**TOWN OF BAY HARBOR ISLANDS
MORRIS N. BROAD COMMUNITY CENTER
1175 95TH STREET
BAY HARBOR ISLANDS, FL 33154**

DEVELOPMENT & REVIEW COMMITTEE MEETING

ITEM: Review and discussion of the Site Plan Application by Arman Corp., to construct a new 6-unit Townhouse Development to be located at 1085 94 Street. Enclosed are the Site Plans and the Staff Report prepared by Town Planner Michael Miller.

Subject: Site Development Plan Application (3rd DRC Review)
1085 Townhouses – 6 DU Townhouse Complex
1085 94th Street
Bay Harbor Islands Acct. No. SPR24-000025
MMPA Account No. 01-0702-1197

SOUTH ELEVATION (94th STREET)

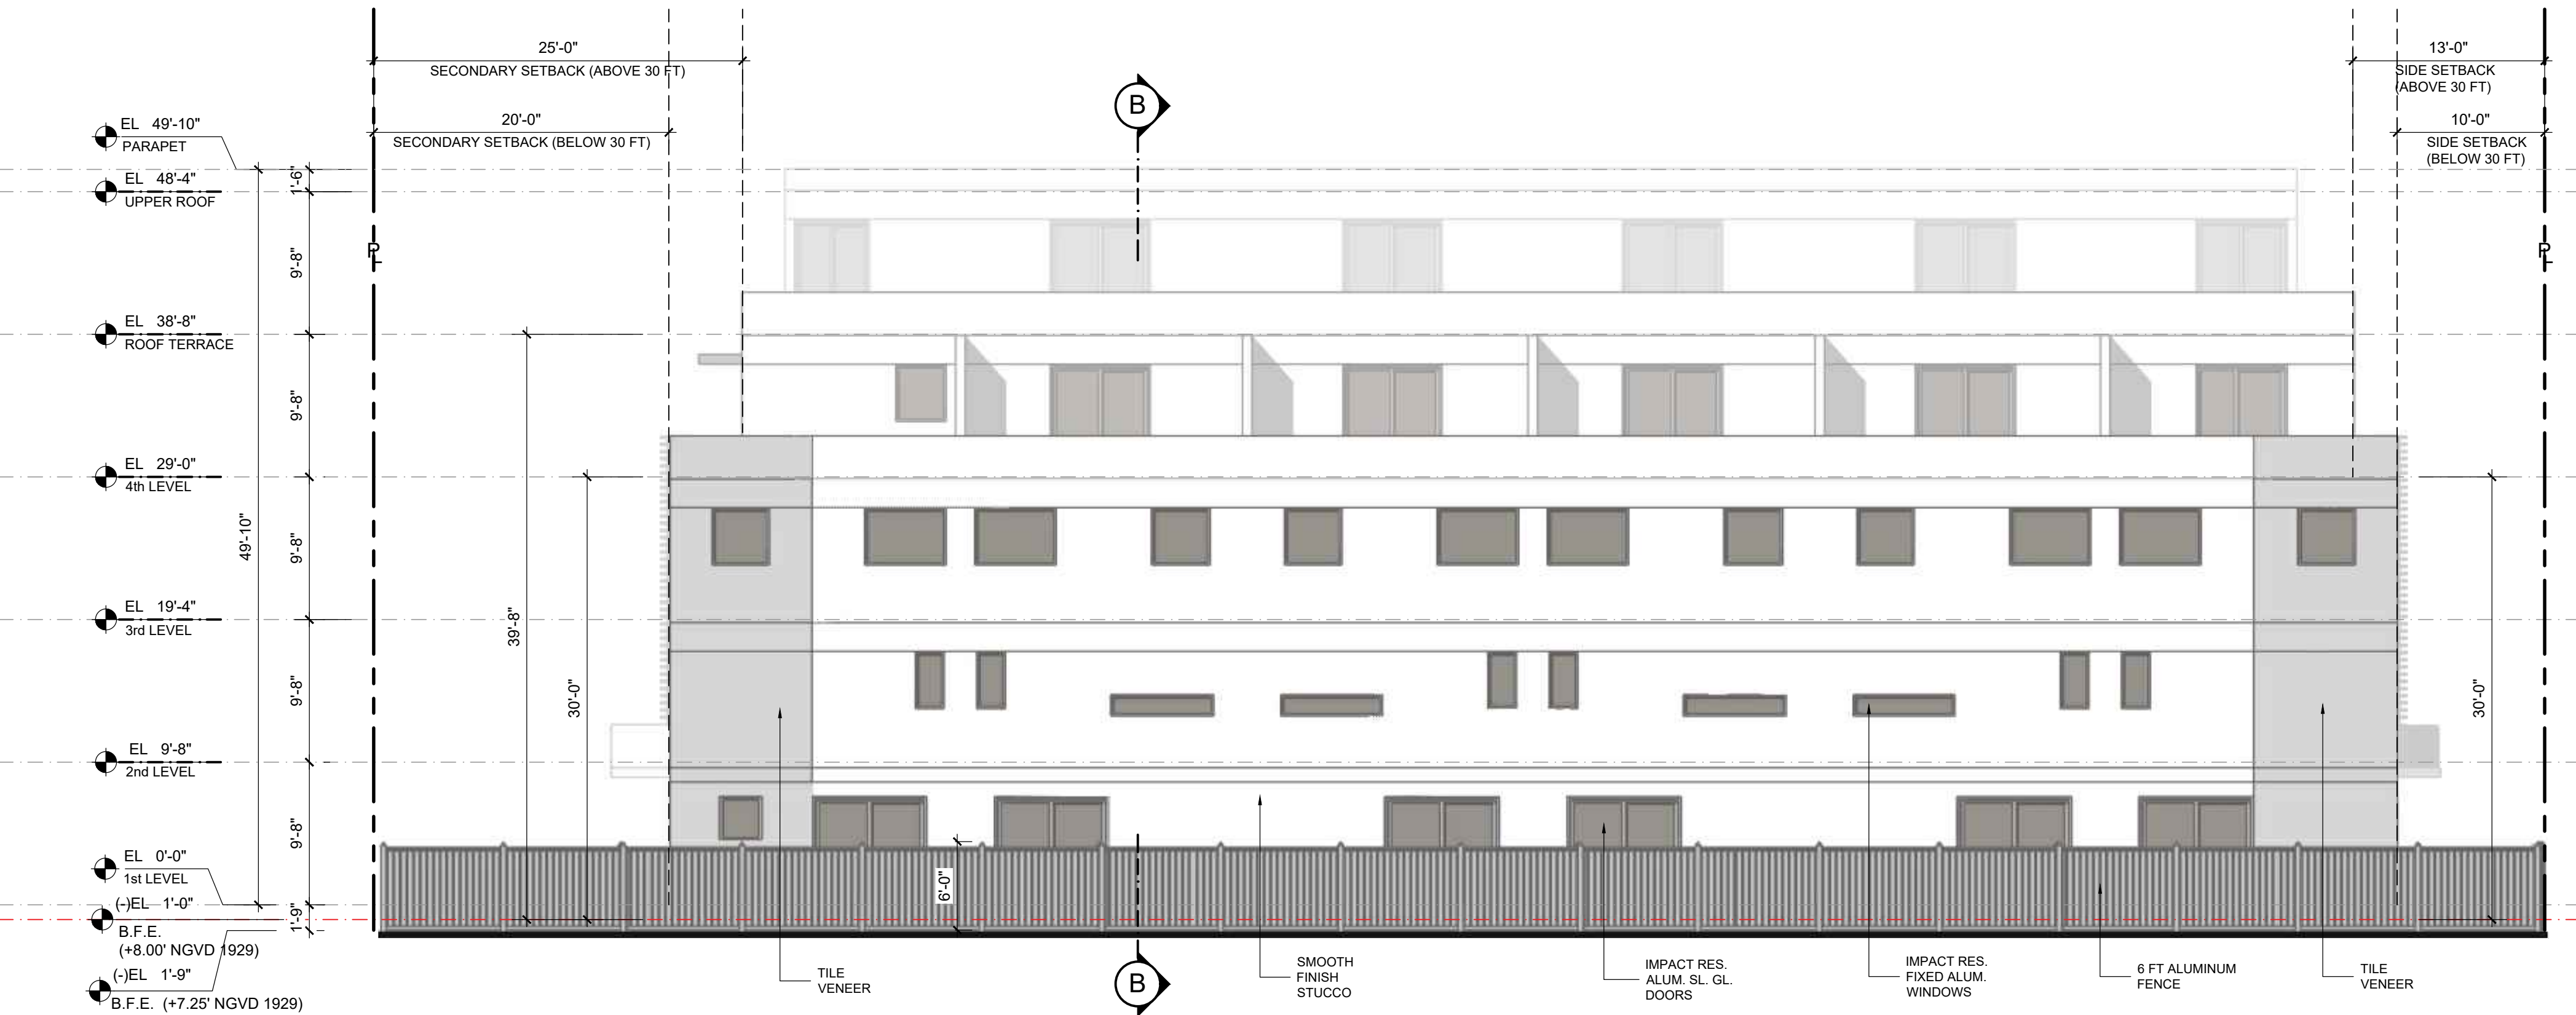
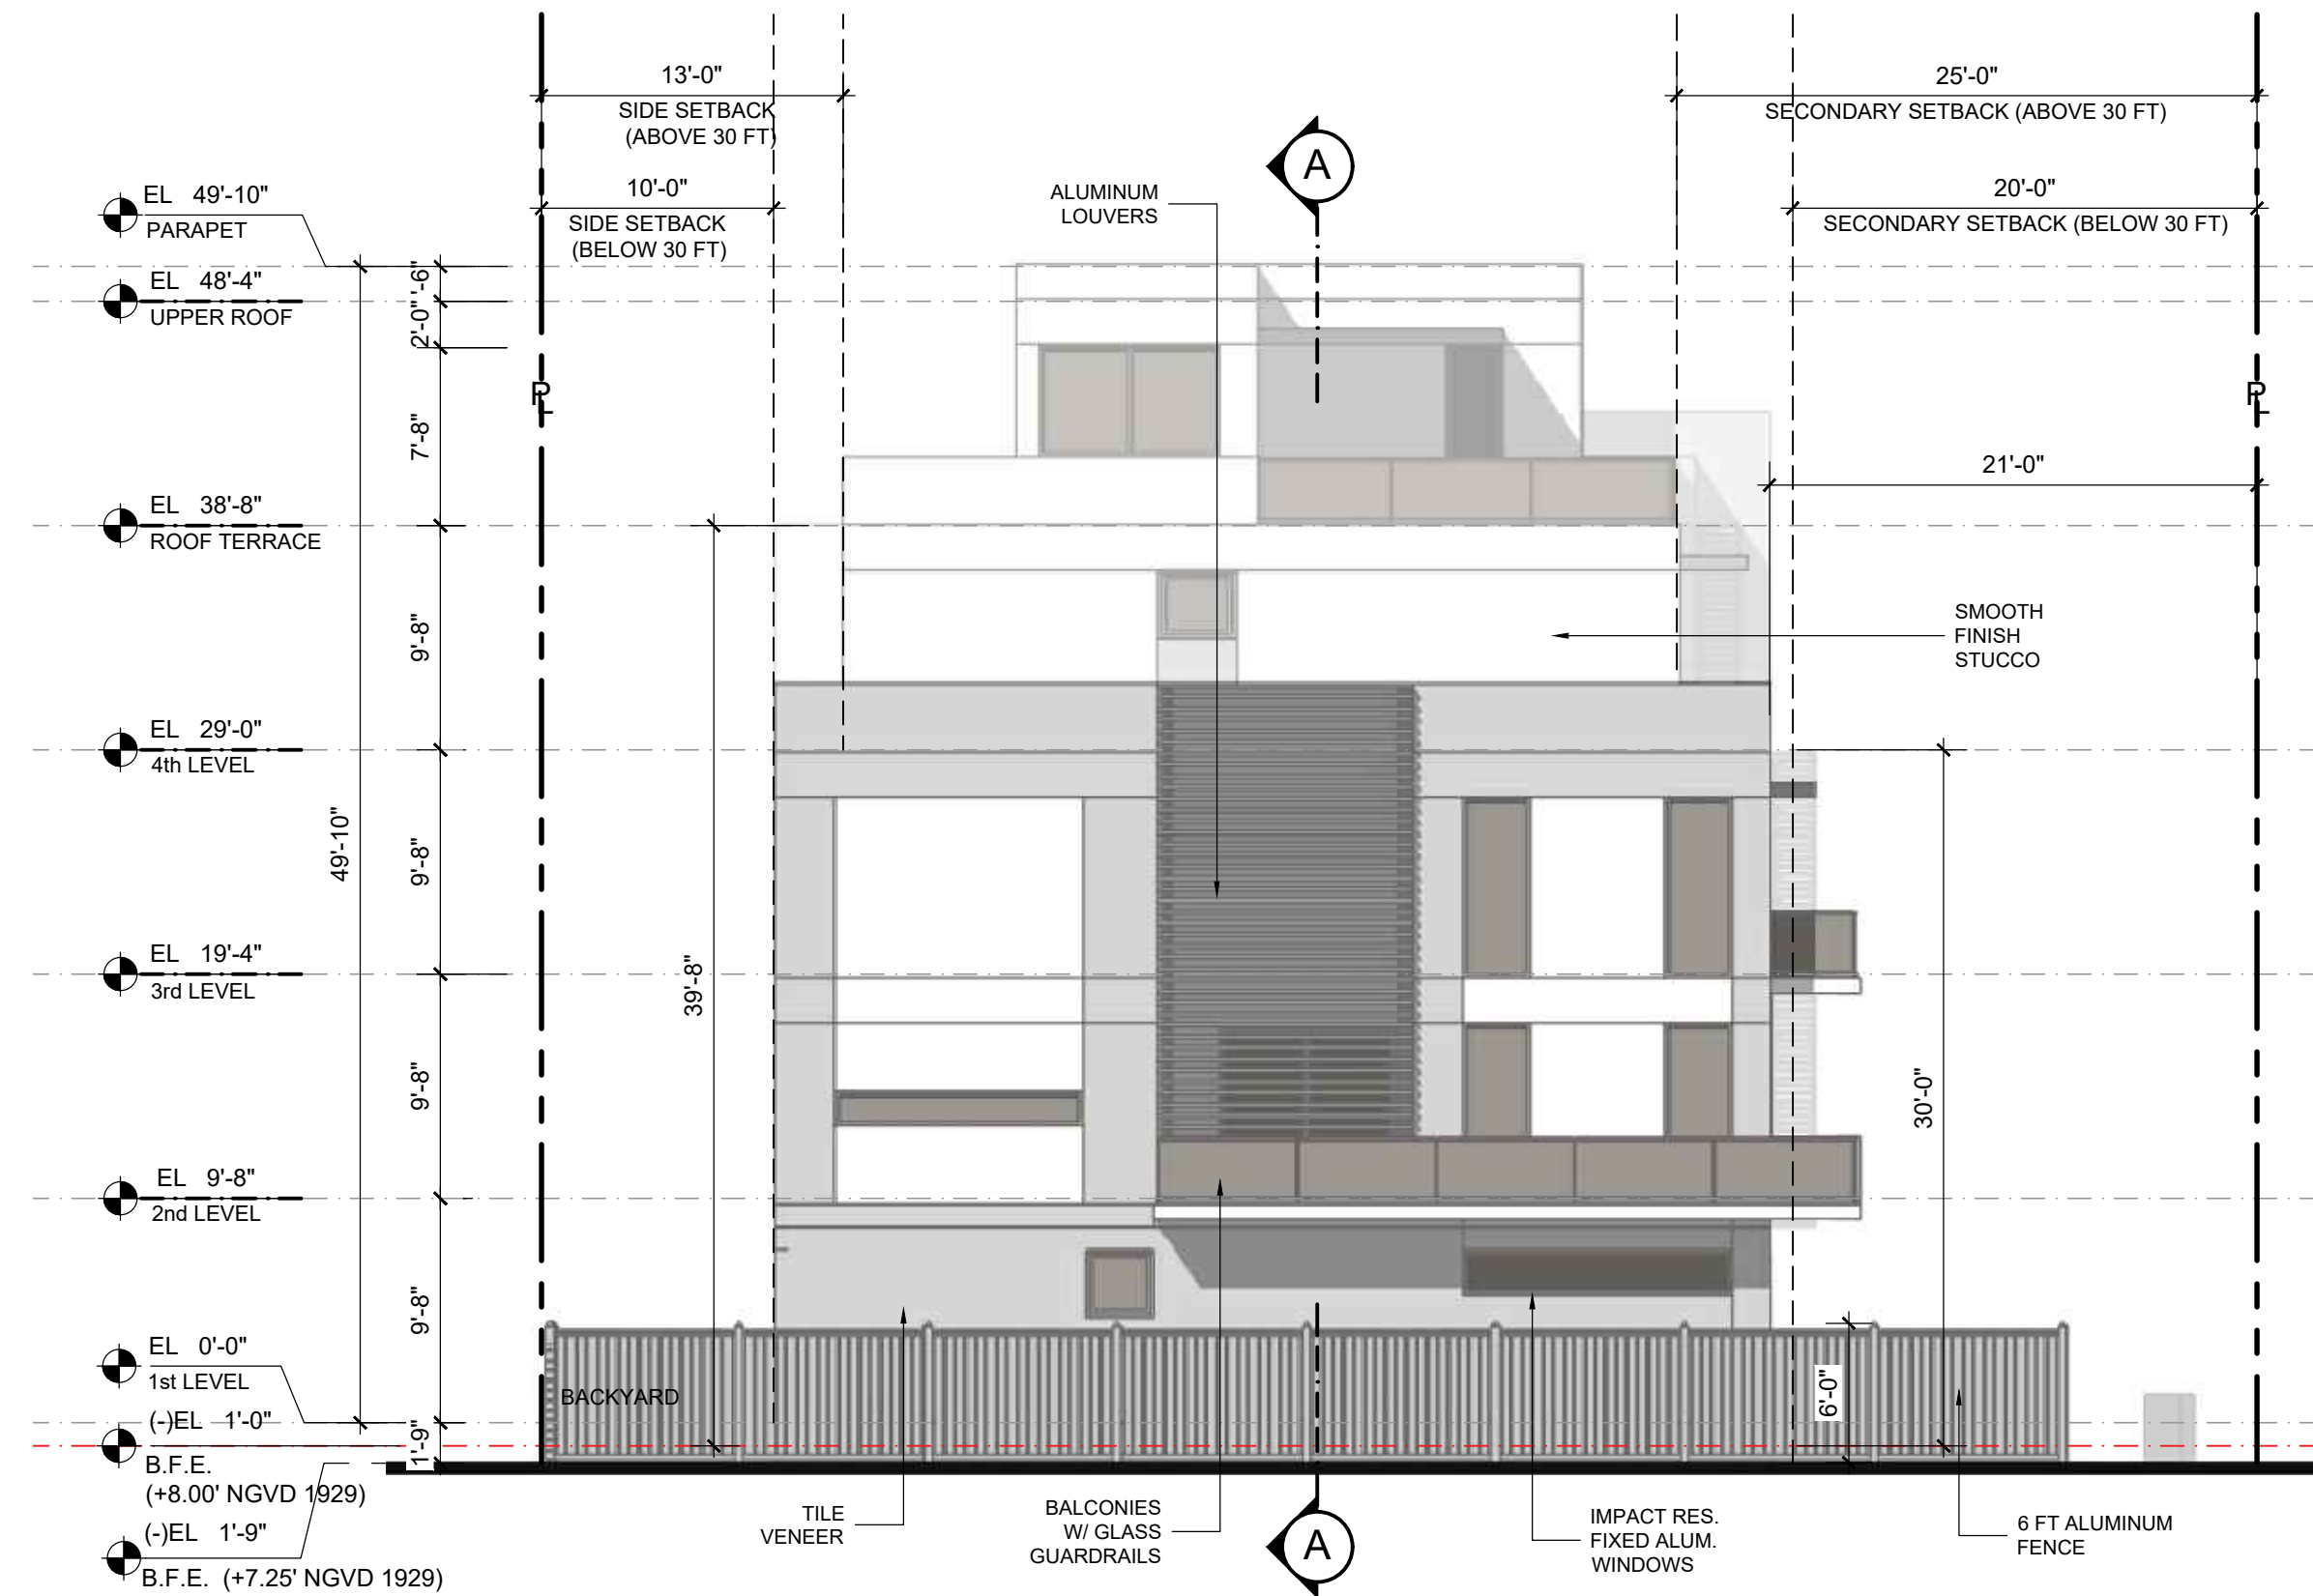
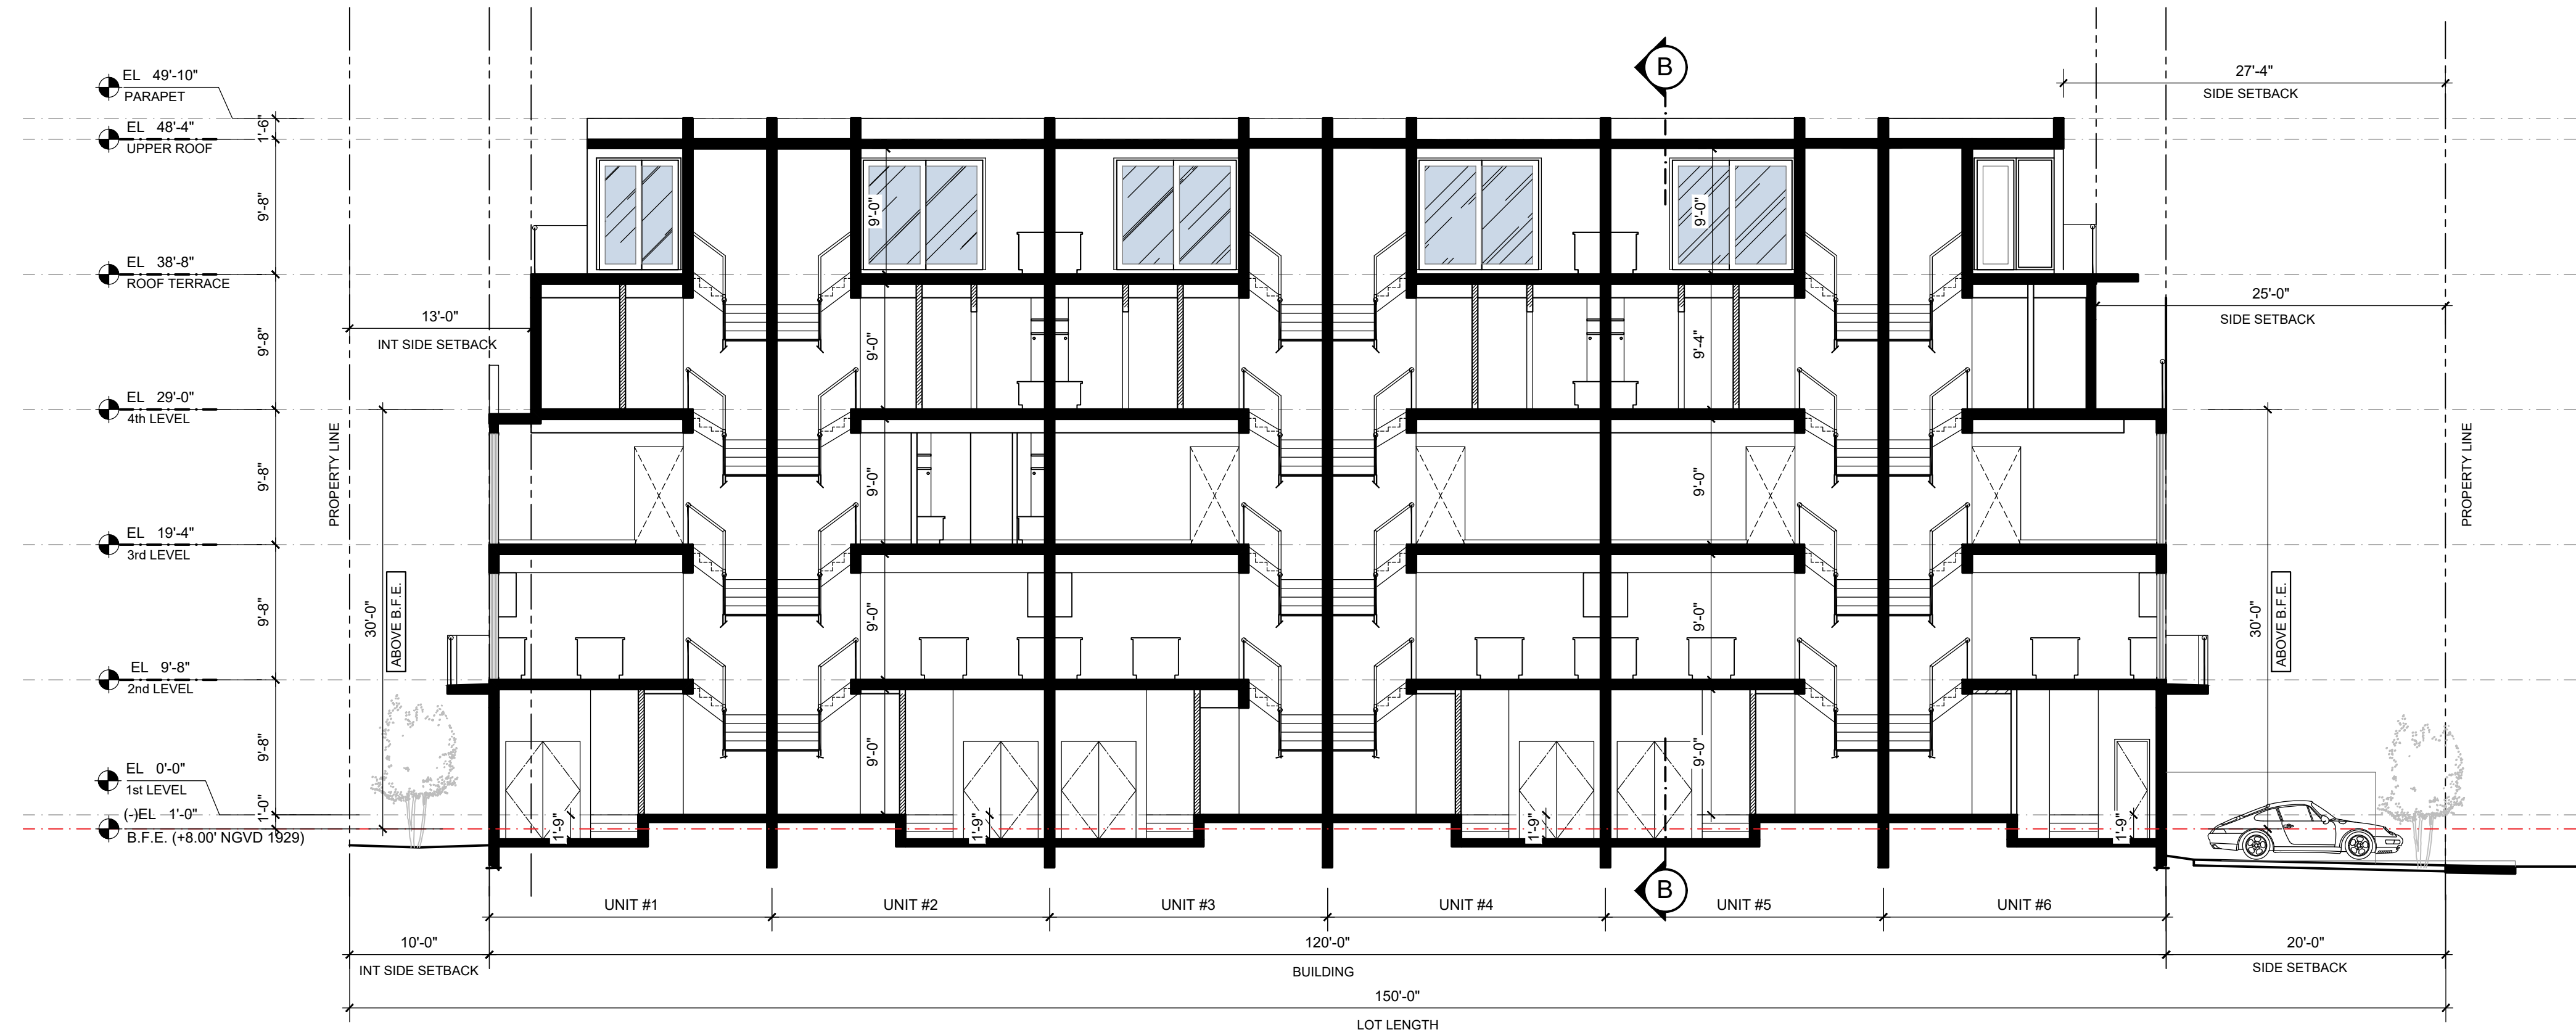
1) Elevation Sheet A-3 / others does not scale to 1/8" = 1'-0". Please check and revise to provide an accurate scale.

e. A drawing scale is provided-1'-0" = 1/8". The drawing is not to scale.

Previous sheet A-3 had printing mistakes. New A-3 with scale 1/8"=1'-0" provided as requested.

Previous sheet A-3 had printing mistakes. New A-3 with scale 1/8"=1'-0" provided as requested.
